# FERMOY WEIR REMEDIATION AND FISH BYPASS CHANNEL

Response to An Bord Pleanála Submissions

Client: Cork County Council

Document Title: Response to ABP Submissions

DRAWING TITLE: WEIR REMEDIATION PLAN OF PROPOSED WEIR			
SCALE: 1:500			(A1)
PROJECT - ORIGINATOR - VOLUME - LOCATION - TYPE - ROLE - NUMBER 19011-TJOC-PL-XX-DR-C-0060			REV: C02

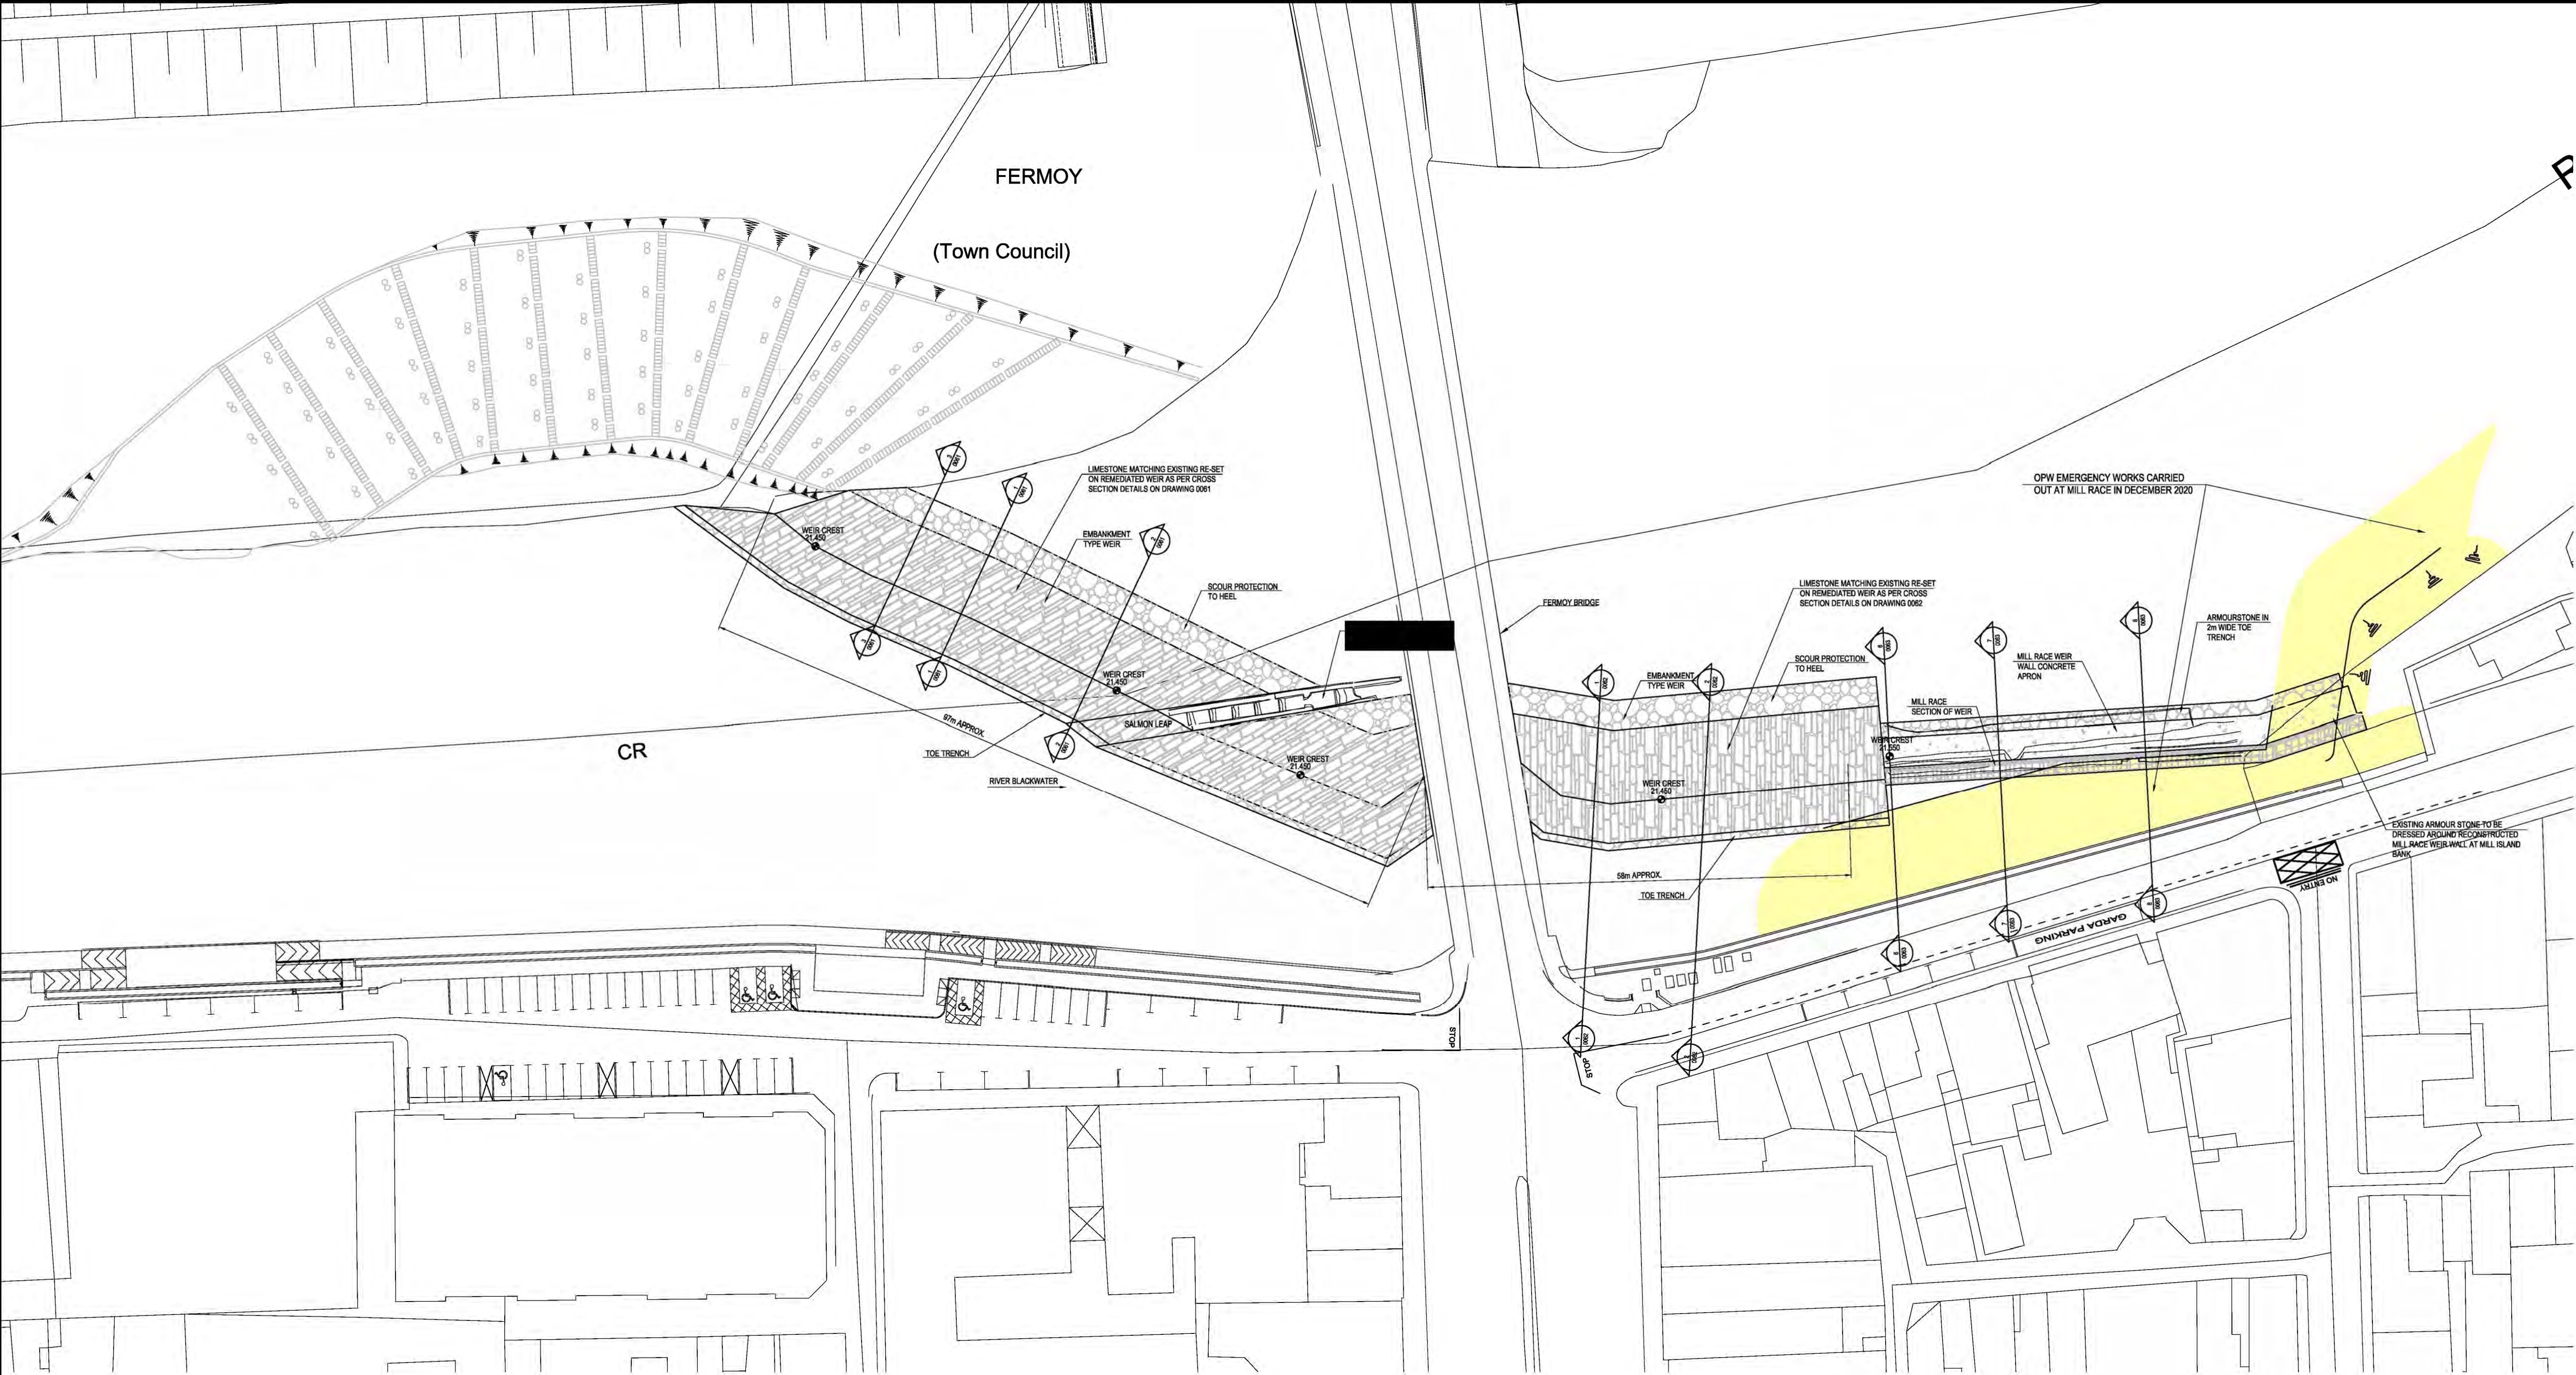
- D. *The labelling of two of the cross sections on plan on drawing 19011-TJOC-PL-XX-DR-C-0060, in the area of the bed stabilisation works is not clear. Thus, arguably, it is not clear what the cross sections are showing, because the labels on plan don't match those on drawing 19011-TJOC-PL-XX-DR-C-0063.*

An inconsistency in the labelling of the cross sections on plan on drawing 19011-TJOC-PL-XX-DR-C-0060, in the area of the bed stabilisation works, has been identified and a revised copy of Drawing 19011-TJOC-PL-XX-DR-C-0060 Rev C-02 is included with other revised drawings in Appendix C.
